Alaska LNG Liquefaction Plant Construction Permit
Application

Alaska LNG Resource Report 9 (Air and Noise Quality)

**DOCKET NO. CP17-____-000
RESOURCE REPORT NO. 9
AIR AND NOISE QUALITY
PUBLIC**

Resource Report No. 9 Agency Comments and Requests for Information Concerning Air and Noise Quality			
Agency	Date	Comment	Response/Resource Report Location
Bureau of Land Management (BLM)	9/26/2016	Not having an approved modeling protocol among the set of documents makes it difficult to assess modeling results. Having published modeling results, even interim results such as appear here, is most unconventional and contrary to concept of a modeling protocol. Several of them have a section "Model Selection". Firstly, this topic should be addressed in the associated modeling protocol. Secondly, in all cases, AERMOD is indicated as the model of choice without any discussion of the potential for complex winds (paragraph 7.2.8 in App. W of 40 CFR. Part 51). There is no justification for why AERMOD was chosen as opposed to (say) a non-steadystate puff model. Once this is properly done, the protocol should be appropriately cited in appropriate places within the modeling report. Another issue is

FIGURE 9.2.2-2

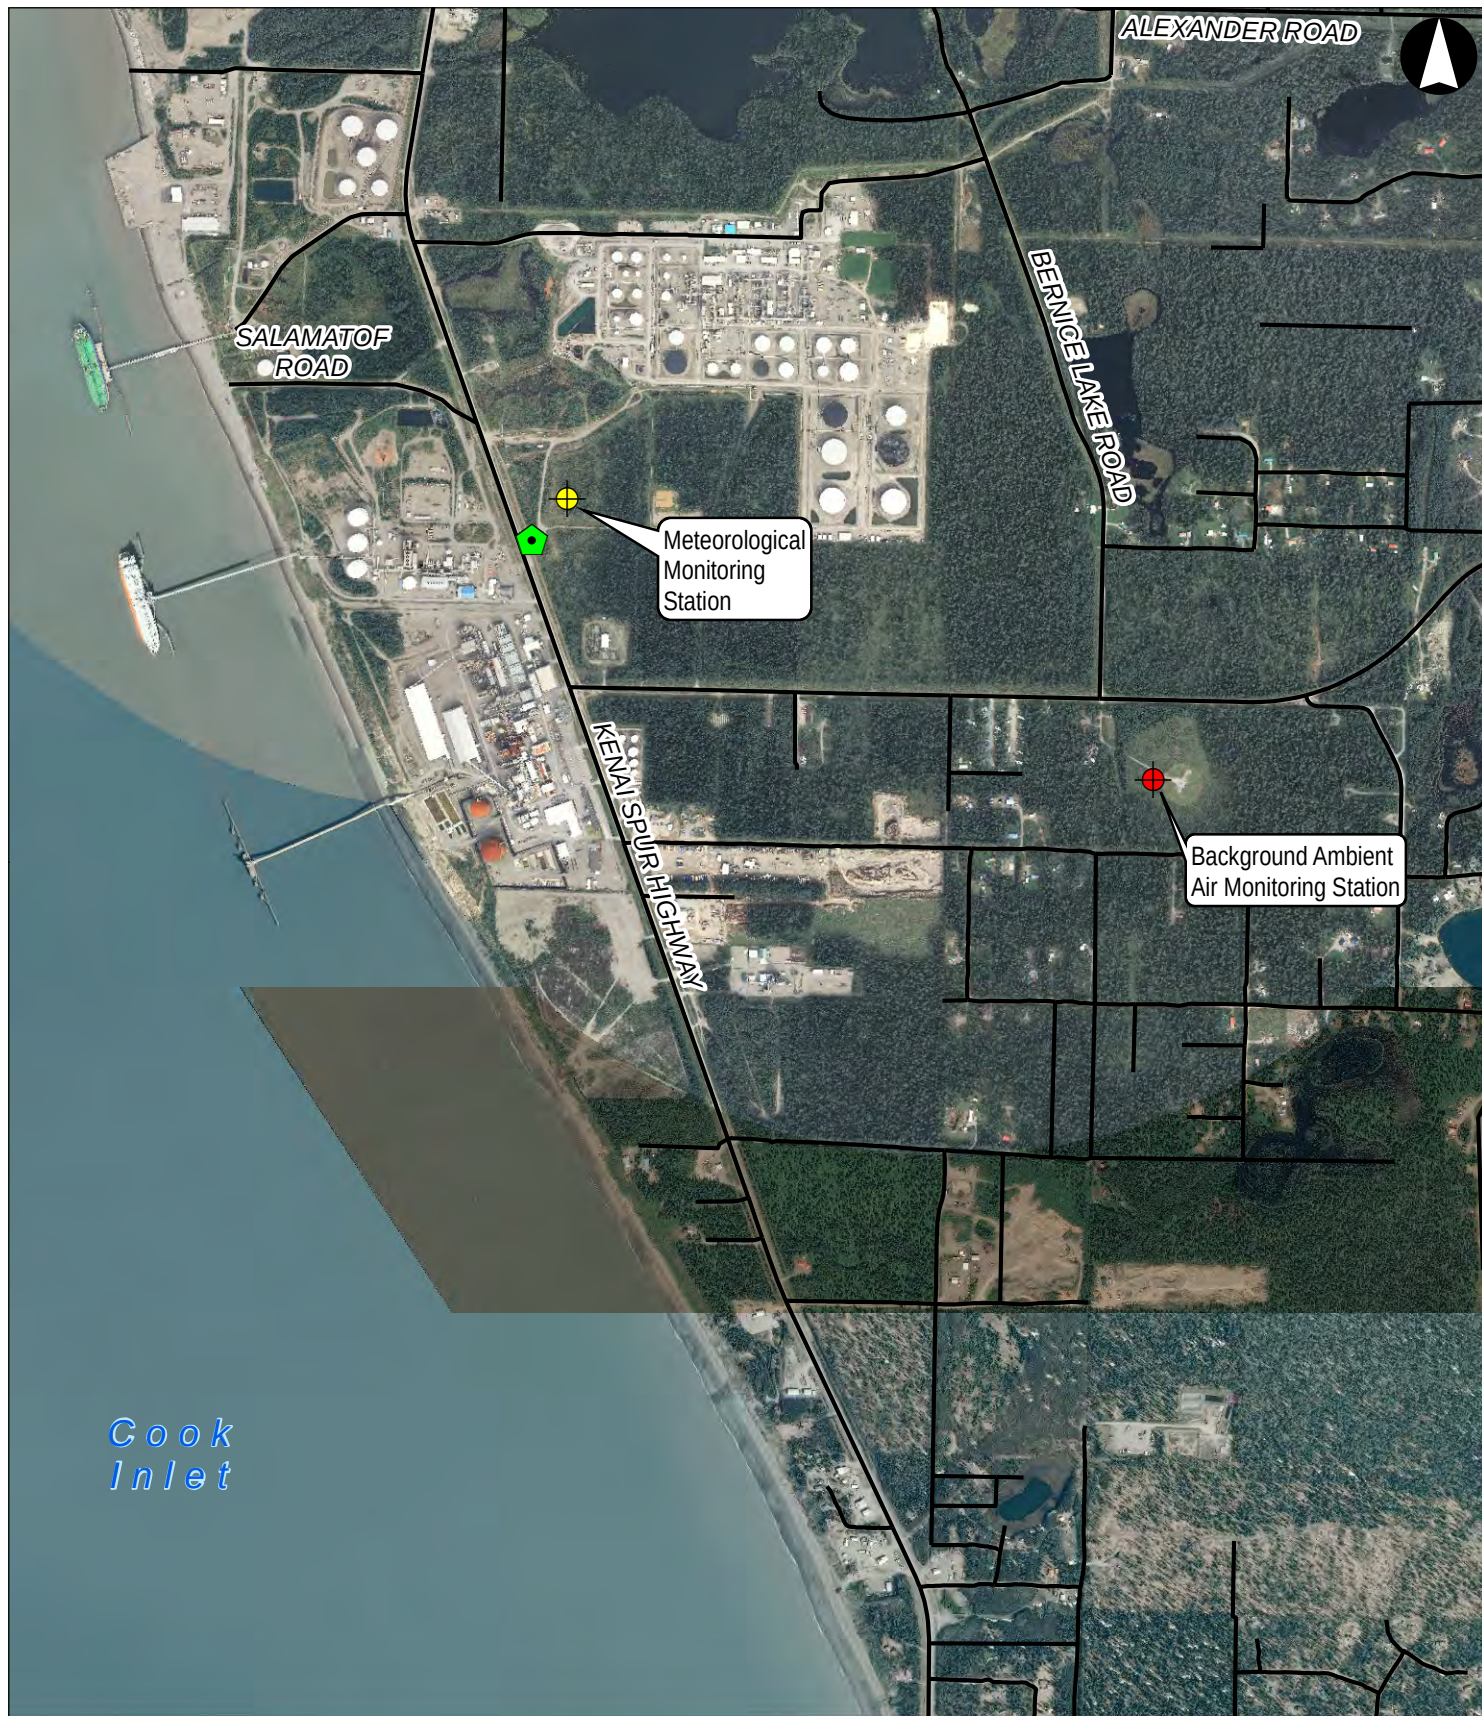
BLM	9/26/2016	Put the report date on the cover page	Comment acknowledged.
BLM	9/26/2016	Fairly good spatial coverage. These monitoring stations operated by private entities and local, state, or federal agencies. Privately collected datasets are generally Prevention of Significant Deterioration (PSD) monitoring programs.	The text has been revised consistent with the comment.
BLM	9/26/2016	EPA, 2009a is an incorrect reference for the citation. Last 3 sentences of the 3rd paragraph: I don't see this in the tables!. There are seven available datasets on the North Slope, which provide a good representation of air quality. Air quality data being collected at this station includes CO, NO2, SO2, O3, PM10, and PM2.5. The proposed location of the second station is identified in Figure 9.2.2-2 as the preconstruction station ... This is NOT indicated in Fig. 9.2.2-2	There are multiple comments, and each is addressed sequentially and included in Section 9.2.2.2 and Appendix B. (1) The sentence has been revised to read "SPM data are not to be used for NAAQS compliance demonstrations without review and acceptance as required in 40 C.F.R. 58.20." with corrected citation. (2) The sentence is revised to state "Data collected at certain stations are above the level of the standards, which do not necessarily indicate exceedance of a standard." (3) The revised text has deleted "at North Slope oil and gas production facilities, as well as remote areas". (4) The data from the proposed location are not used in modeling compliance. The reference to use of data from the proposed location of the second station has

Resource Report No. 9 Agency Comments and Requests for Information Concerning Air and Noise Quality			
Agency	Date	Comment	Response/Resource Report Location
			been removed, and the text is revised. The location is therefore not in Figure 9.2.2-2.
BLM	9/26/2016	The transient nature of fugitive emissions should be emphasized.	Section 9.2.3.1.1.3 is updated to state "Except for emissions from storage piles, fugitive emissions from construction activities are transient in nature and likely occur at any one location for short periods within a single day."
BLM	9/26/2016	caption: Total Annual Construction Emissions for the Liquefaction Facility and Marine Terminal	The caption has been revised.
BLM	9/26/2016	Combined PM10 emissions from all spreads peaks in Year 5.	This sentence is found in Section 9.2.3.3.1.1.
BLM	9/26/2016	1st full paragraph: as stated in general comments (above), the justification for use of AERMOD is not properly made. It should be properly made in the modeling protocol and then that document referenced here.	Justification for use of AERMOD is provided in Appendices D, E, and F.
